**Curragh Bord and Pillar Mine Project**

# **Response to DESI Information Request**

**for Coronado Global Resources Inc**

26 July 2024

**Figure 13**  
09/05/2024

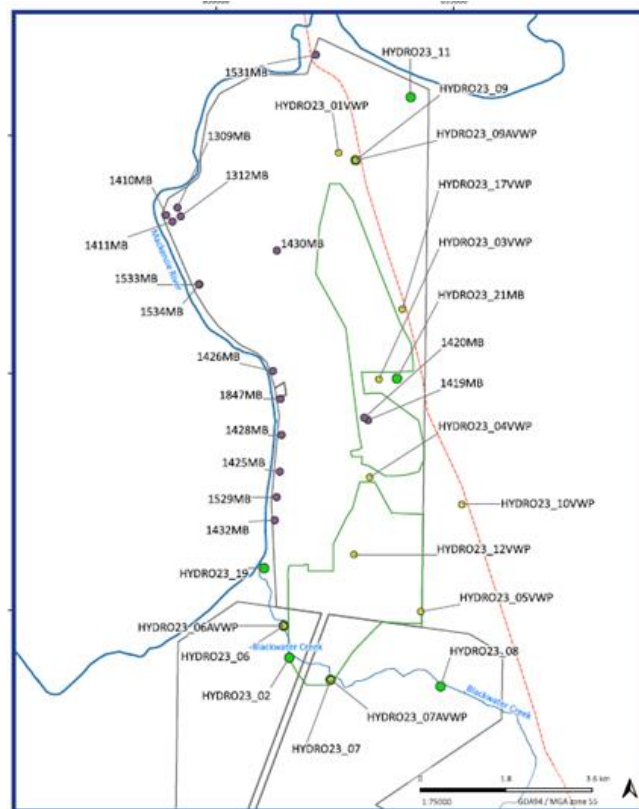
Figure C45 of Appendix B – Groundwater Report demonstrates the predicted depressurisation in the Mammoth coal seam. As shown below, the figure indicates that depressurisation is restricted along the eastern side by the Jellinbah fault, however, in the southeast the predicted depressurisation appears to extend outside of the boundary of ML80110.

It is noted that the only monitoring of groundwater levels in the area where depressurisation is predicted to occur outside the mining lease is via vibrating wire piezometers (VWPs).

The department has noted at varying locations in Queensland that data coming from a number of VWPs often has significantly different trends and absolute water level elevation than that measured in nearby standpipe bores in the same formations. In some instances, the majority of the VWPs are considered to be providing erroneous data. It is therefore recommended that some standpipe bores are drilled into the coal measures in this south-eastern area to provide confidence in the understanding of mining impacts. Data from the standpipe bores can also be used to validate data provided from the existing VWPs.

Revise the Curragh groundwater monitoring network to include standpipe bores in the southeastern area where depressurisation is predicted outside the mining lease boundaries to better monitor the impacts from mining.

As shown in Figure C45 of the EAR Groundwater Report, the majority of the extent of predicted depressurisation of the Mammoth Seam is within the existing Curragh mining leases with a small area of partial depressurisation extending to the east of the southern end of ML 80110. In this off-lease area, the depth of the Mammoth coal seam ranges from approximately 170 m to 280 m below ground level (EAR Groundwater Report Figure 11).

Both the Mammoth Seam and the overlying Permian overburden are classified as aquitards (low permeability units that impede groundwater flow). Due to the low permeability of the strata, the partial depressurisation of the Mammoth Seam in the off-lease area is not predicted to result in any drawdown in the unconfined groundwater table in the overlying Permian overburden.

In addition, there are no aquifers, groundwater users, or groundwater dependent features in the off-lease area. Hence, the partial depressurisation of the Mammoth coal seam aquitard, in itself, is not a significant groundwater effect and there are no aquifers, groundwater users or groundwater dependent features in this area that could potentially be impacted. Consequently, there are no EA groundwater monitoring bores proposed, or necessary, for the project in this area. In addition, an open standpipe monitoring bore screened in the Mammoth coal seam in this area would be impractical due to the difficulty and cost associated with installing, monitoring and maintaining an open standpipe bore at this depth (almost 300 m).

As described in EAR Section 6.5, there are three new EA monitoring bores proposed within the extent of predicted drawdown from the project on the unconfined water table, in the vicinity of Blackwater Creek. The purpose of these monitoring bores is to confirm the actual extent of drawdown on the unconfined groundwater table and to identify any significant departures from the predicted drawdown magnitude and extents.

In response to DESI's issue, Coronado is proposing to include an additional standpipe monitoring bore (HYDRO\_08MB) in the EA groundwater monitoring program (refer Figure 1). This bore is located adjacent to Blackwater Creek and near the limit of the predicted Mammoth seam depressurisation to the south-east of the Underground Mining Area. This monitoring bore is ideally located to identify any unexpected changes in the unconfined groundwater table below Blackwater Creek and any associated environmental features.
